Enclosure to PLA-3968:

**SAFETY ANALYSIS OF PROPOSED
AMENDMENT TO TECHNICAL SPECIFICATION 4.6.2.1**

A change to the SSES Technical Specification (4.6.2.1.d) is proposed to decrease the test frequency of the low pressure drywell-to-suppression chamber bypass leak test to coincide with the test frequency for the Type A Integrated Leak Rate Test (ILRT).

FIGURE 1: POTENTIAL BYPASS FLOW AREAS

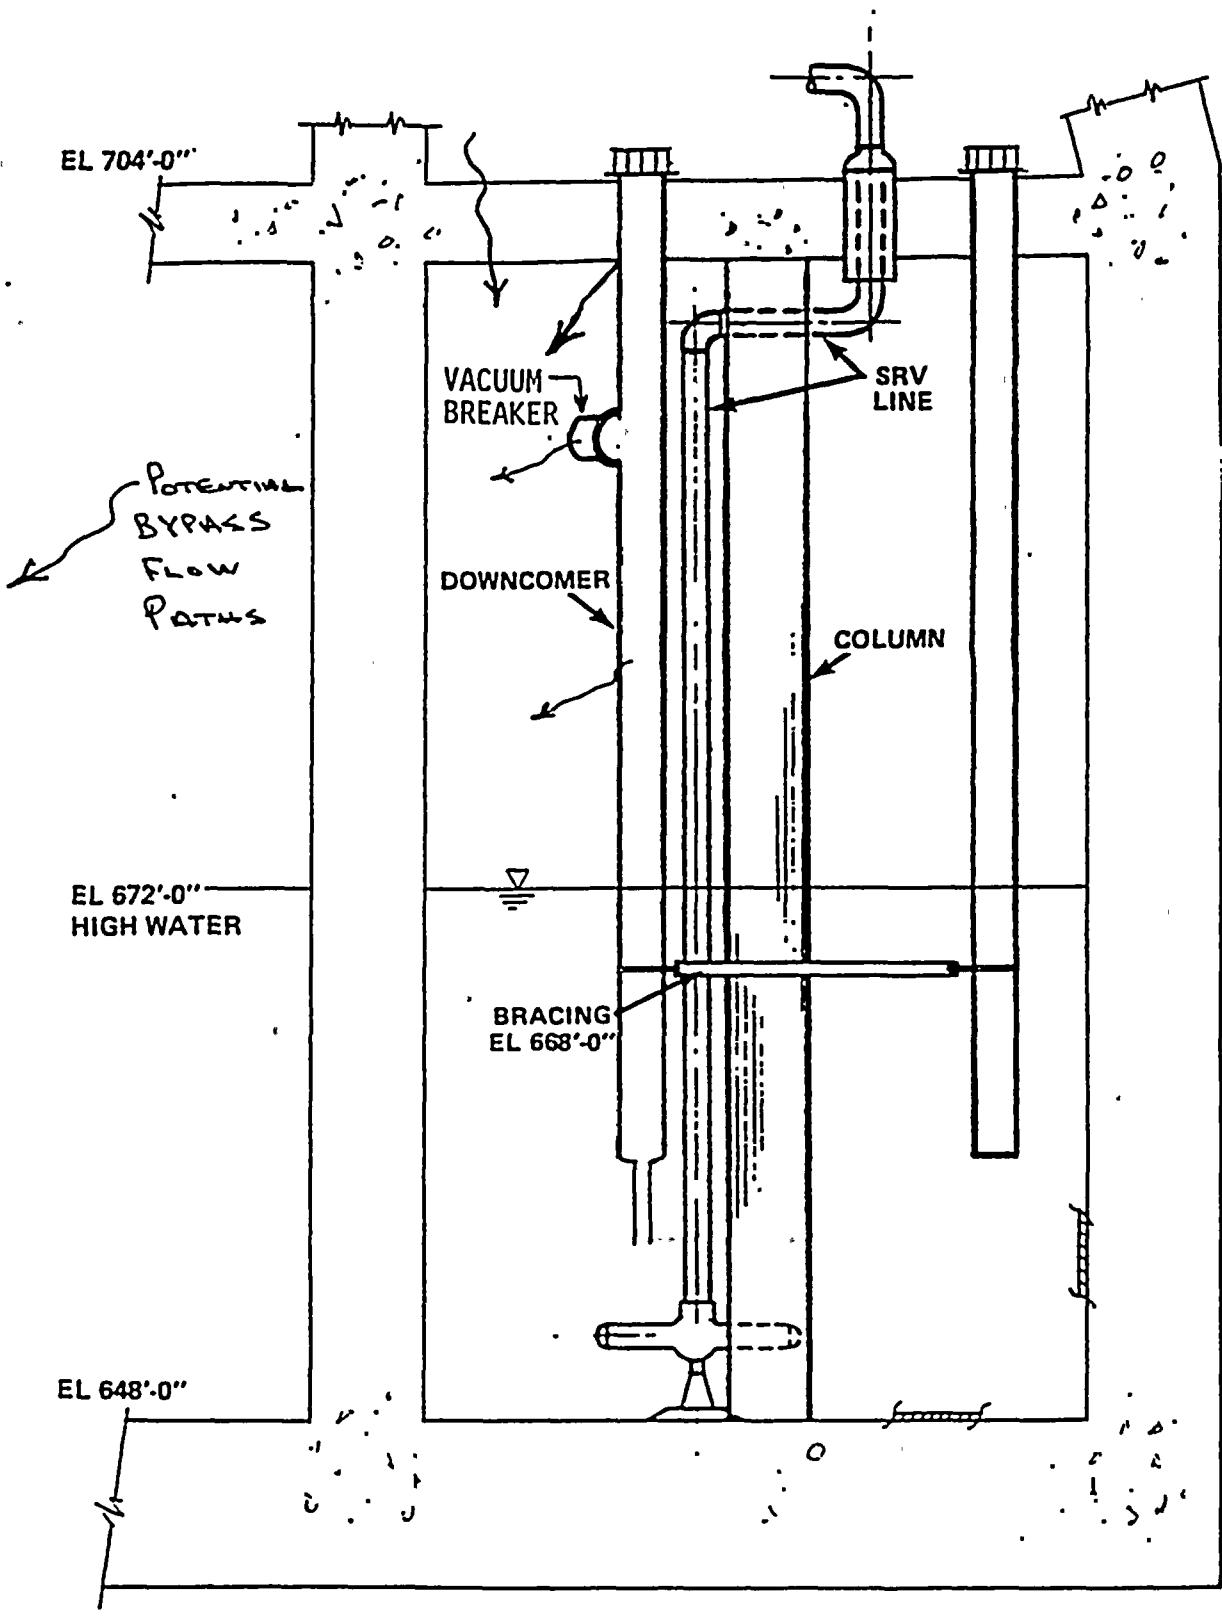
Potential bypass leakage originates from two flow paths (see attached Figure 1):

1. Non-VB sources such as leakage through the diaphragm floor penetrations (SRV discharge line and downcomers), cracks in the diaphragm floor/liner plate and cracks in the downcomers that pass through the suppression pool airspace.
2. The five sets of drywell-to-suppression chamber containment VBs.
